## CITY OF TONTITOWN PLANNING OFFICE

Meeting: **August 28, 2018**  
Project: **South Pointe Phase 1**  
Planner: Courtney McNair

### FINAL SUBDIVISION PLAT APPROVAL REQUEST

**SUMMARY:** South Pointe Subdivision Phase 1 is requesting Final Plat approval for 60 residential lots and one detention lot on 21 acres. This request will also need to include the lift station that is under construction to service this development.

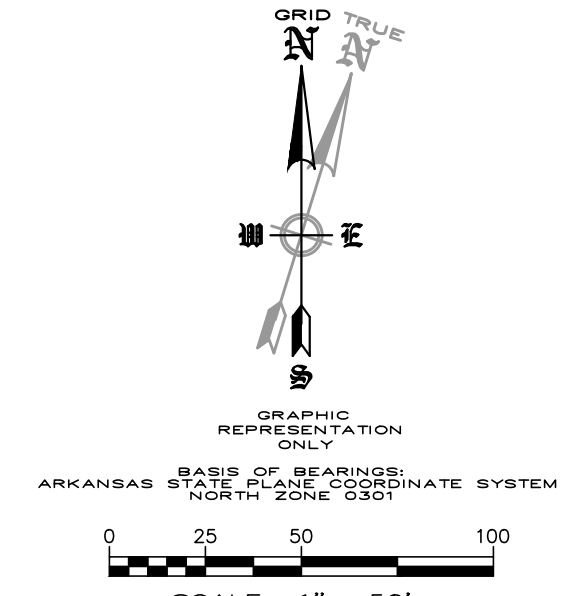
- (1) All water lines in-place, pressure tested, and bacterially tested safe.
- (2) All hydrants and valves in-place, accessible, and operational (facing street).-**The Fire Marshal is requiring an additional hydrant be added.**

**FINAL PLAT**  
**SOUTH POINTE SUBDIVISION PHASE I**  
**TONTITOWN, WASHINGTON COUNTY, ARKANSAS**  
SCALE: 1"=60' | DATE: August 24, 2018 | DRAWN BY: RKW  
**ENGINEERING SERVICES, INCORPORATED**  
**SPRINGDALE, ARKANSAS**

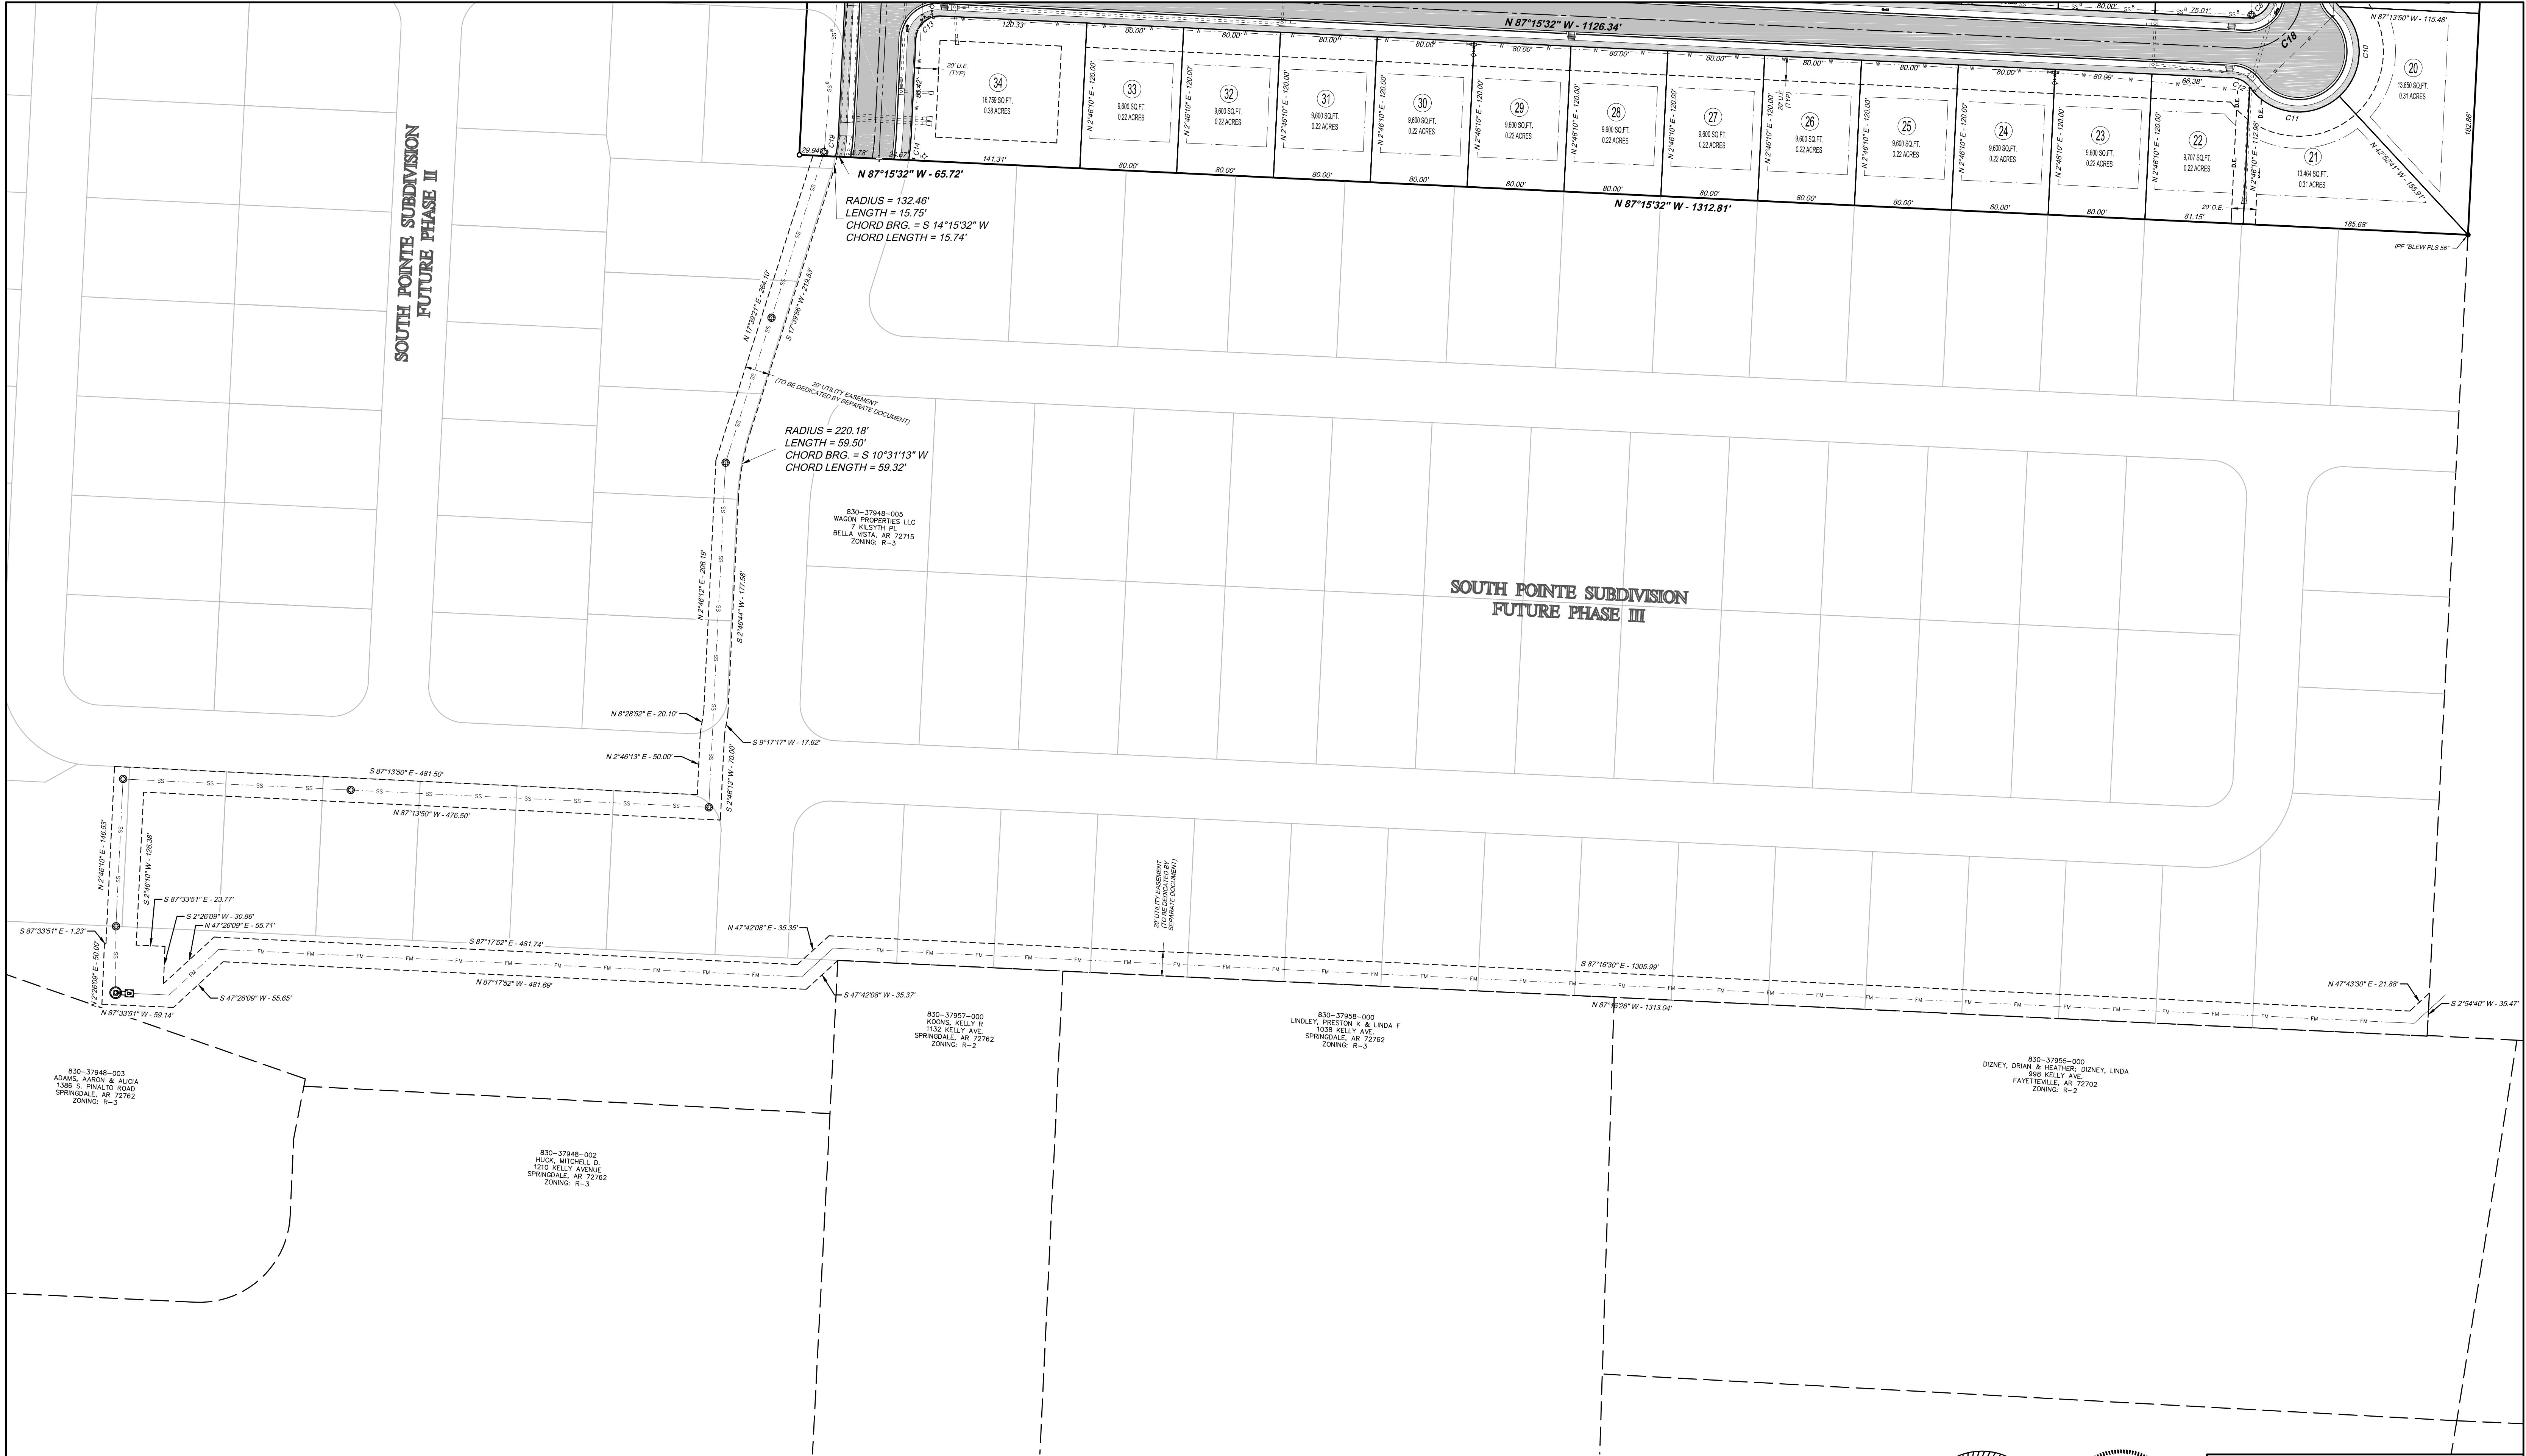
This project is not ready for Final Plat, and Staff is recommending that it be Tabled to next month's meeting. Several items that are required for Final Plat are not complete:

- (1) All curb and gutter and street drainage slopes completed and backfilled. -**All curbs are not poured**
- (2) Final layer of asphalt in-place.-**There is no asphalt**
- (3) Street signs paid for.-**This is not complete**
- (4) Pedestrian accommodations constructed.
- (5) Road right-of-way restoration substantially complete.-**Not complete**

(D) *Drainage.*-**The detention is inadequate. The engineer for the project is requesting that the increase be resolved with Phase 2. There must be a solution (temporary may be ok) prior to Final Plat for Phase 1. No revised Drainage Report has been received yet.**

**There are known flooding problems downstream of this project, and the City cannot risk this problem being increased.**

- (3) Outlet structures, pilot channels, headwalls, flumes, and other appurtenances in place and constructed to approved plans and specifications.-**all stormwater structures are not constructed.**

**STAFF RECOMMENDATION:** Staff recommends to TABLE the Final Plat of South Pointe Subdivision Phase 1 as there are many outstanding items not complete, and concerns with the drainage system.
